**NORTH SALT LAKE PLANNING COMMISSION  
NOTICE & AGENDA  
May 24, 2022  
6:30 p.m.**

**TO:** Planning Commission  
**FROM:** Mackenzie Bennett, Planner  
**DATE:** May 24, 2022  
**SUBJECT:** Site Plan Amendment for the Collective Campus, 1375 West Center Street

# COLLECTIVE CAMPUS BUILDING RENOVATION

SITE PLAN APPLICATION - REVISED

**CIVIL SITE PLAN**

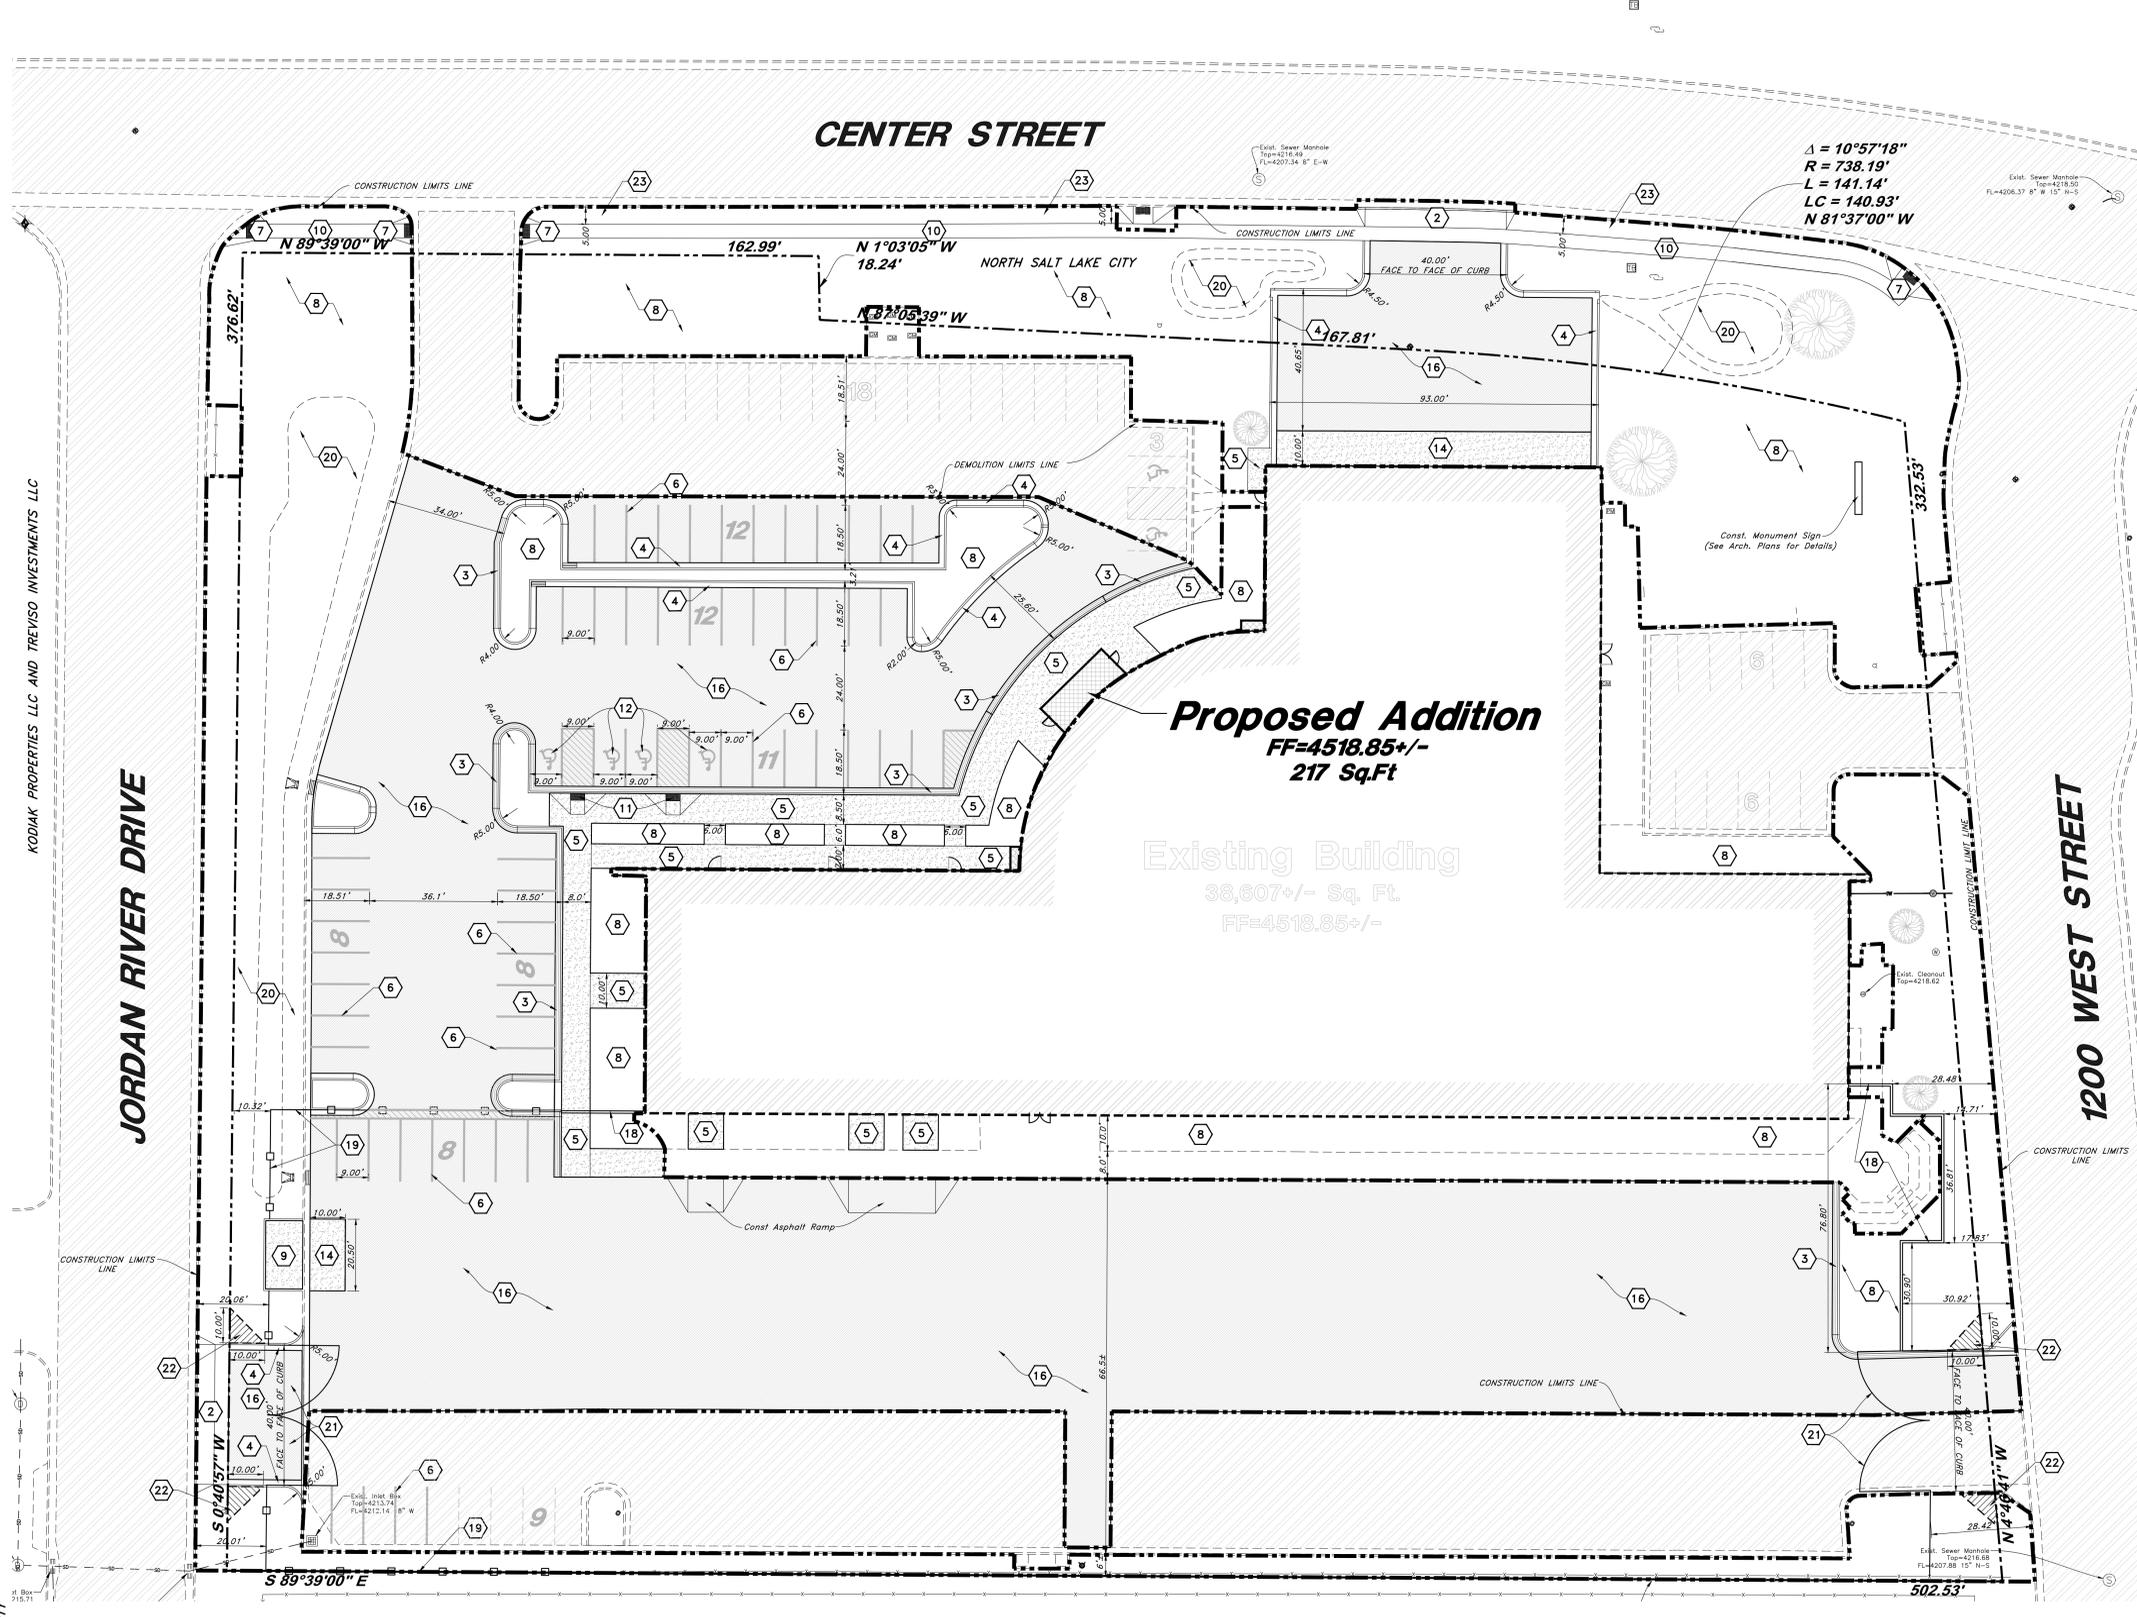
**Driveway Access:** The subject property has one existing 30 foot driveway on Center Street and two 25 foot driveways on 1200 West. The proposed plan adds one new 40 foot driveway on Jordan River Drive,

one 40 foot driveway on Center Street, and expands the southernmost existing 25 foot driveway on 1200 West to a total width of 40 feet.

The new driveway on Jordan River Drive and expanded 40 foot driveway on 1200 West will be used to access the gated outdoor storage area and 17 parking stalls for some employees such as those who work in the mechanic shop or equipment yard. The gate will be open during normal business hours. The applicant must work with the South Davis Metro Fire Agency to ensure access to the fenced area in the event of an emergency.

The new 40 foot driveway on Center Street will be used to access the mechanic shop. The applicant has indicated that the traffic generated to this driveway will be no more than 10 vehicles or pieces of equipment per day. The area that is to be used as the mechanic shop was the school gymnasium. The applicant will add 4 bay doors to the wall facing Center Street for access to the shop.

City code 10-6-2 allows non-residential lots up to two driveways on any frontage greater than 200 feet. This property has 3 frontages, each with a length of approximately 400+/- feet. The City Engineer has reviewed the placement of the existing and proposed driveways and deemed them compliant with code.

**Parking:** The parking layout was altered and brought into compliance with the current City code regarding landscaped parking islands, drive aisles, and access routes. The parking requirements are calculated below:

The Americans With Disabilities Act requires that when there are 101-150 parking stalls in a parking lot, there must be a minimum of 5 ADA stalls. The applicant has provided 6 ADA stalls and therefore complies.

**Outdoor Storage:** The outdoor storage area is behind the building (to the south) and along 1200 West. This area will be used to store construction equipment and on occasion, construction materials. The entire area will be paved with asphalt and accessible during business hours when the gate is unlocked and open.

The outdoor storage area will be screened from the public right of way of 1200 West with a 6 foot precast concrete wall with a stone pattern. The wall will be setback a minimum of 20 feet from the road, except when adjacent to the existing outdoor amphitheater area. To preserve the existing amphitheater feature, the wall will go within 14.71 feet of the road at the closest point and then jog back to a 28.48 foot setback where it will then connect to the building.

The rear yard setback area will be fenced along Jordan River Drive with a 7 foot chain link fence, with a mesh screening material. The fence will be setback a minimum of 20 feet from the road. It will have 3 strands of tightly strung barbed wire on top of it for security purposes. Both access driveways for the outdoor storage area will have a 7 foot chain link gate that swings into the property and is screened with the same mesh material. The gates will have 3 strands of tightly strung barbed wire on top. All the walls, fences, and gates are compliant with City code.

The Development Review Committee (DRC) recommends approval of the site plan amendment for the Collective Campus located at 1375 West Center Street with the following conditions:

1. Completion of Engineering redlines;
2. Provide South Davis Metro Fire with access to the gated outdoor storage area and parking on the south side of the property.

LANDSCAPE PLAN

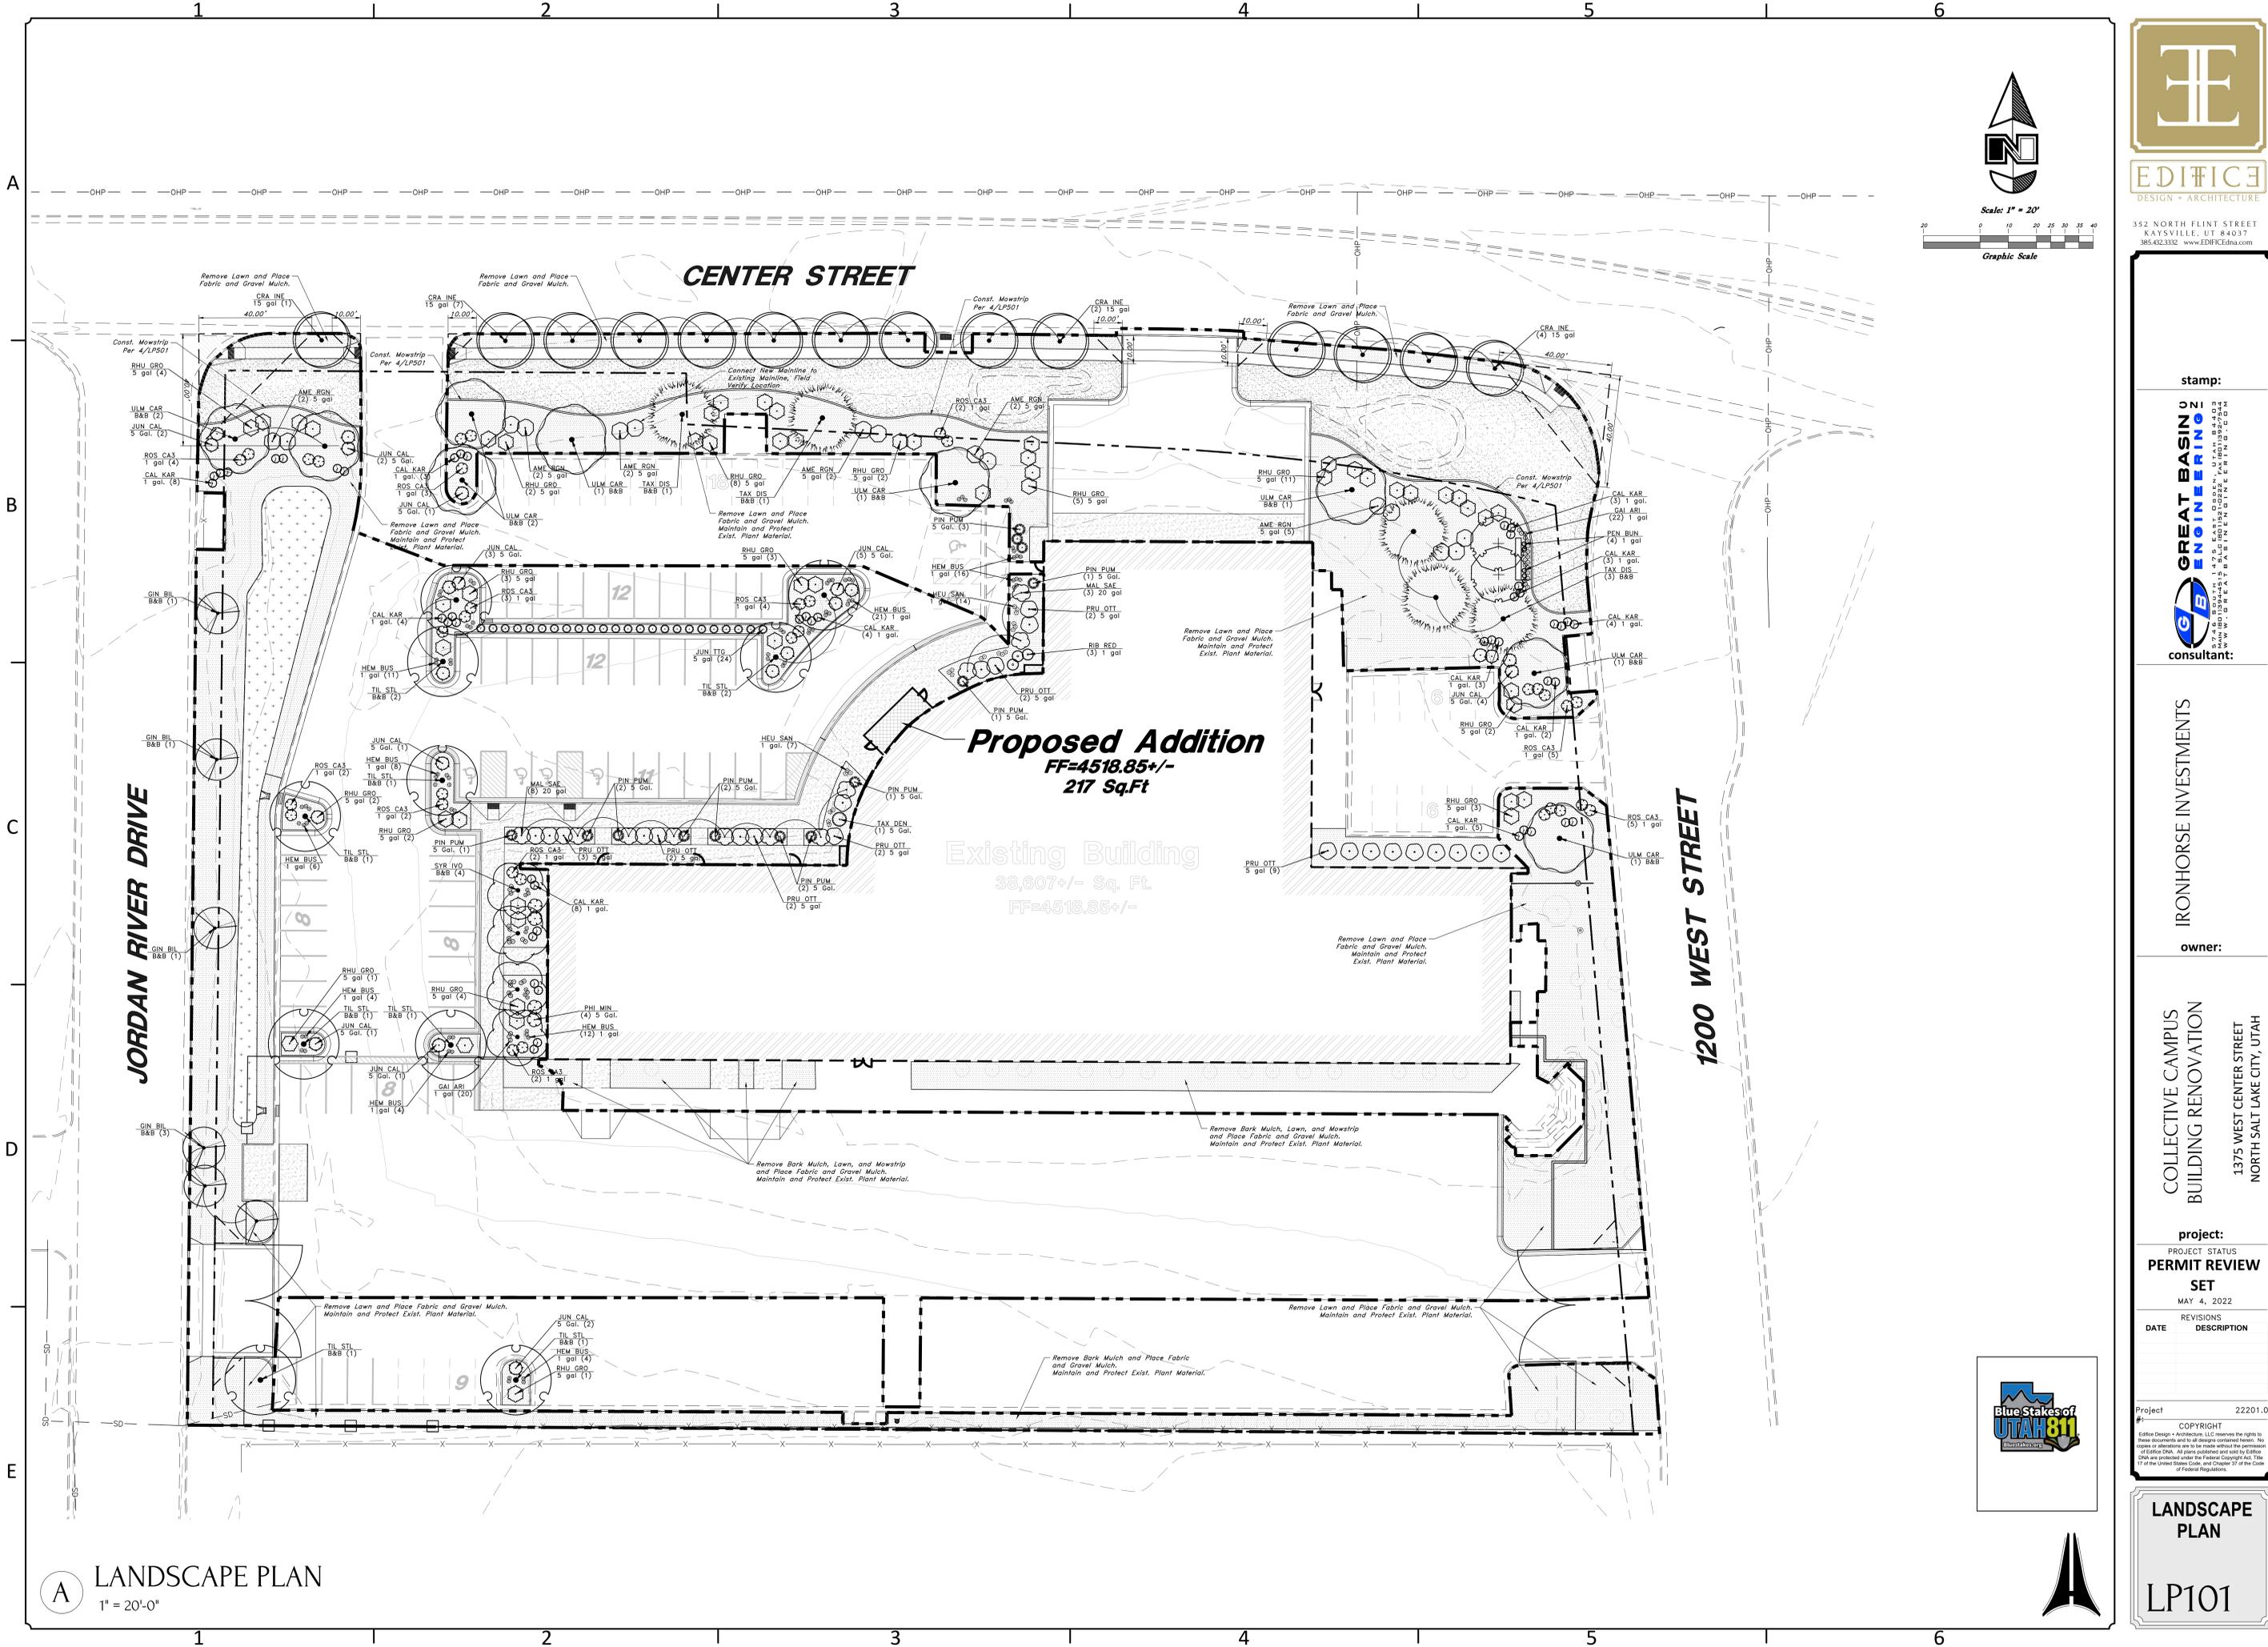
**Landscaping:** According to the current code, the minimum required landscaping in the MD zone is 10% of the property. The proposed plan provides 19% landscaping (33,532 sq. ft.). Of that square footage, 12,264 sq. ft. will be sod which equals 37% of the landscaped area and 7% of the entire lot (buildings/hardscape included). The applicant has complied with the street tree ordinance and regulations regarding landscaped parking islands.
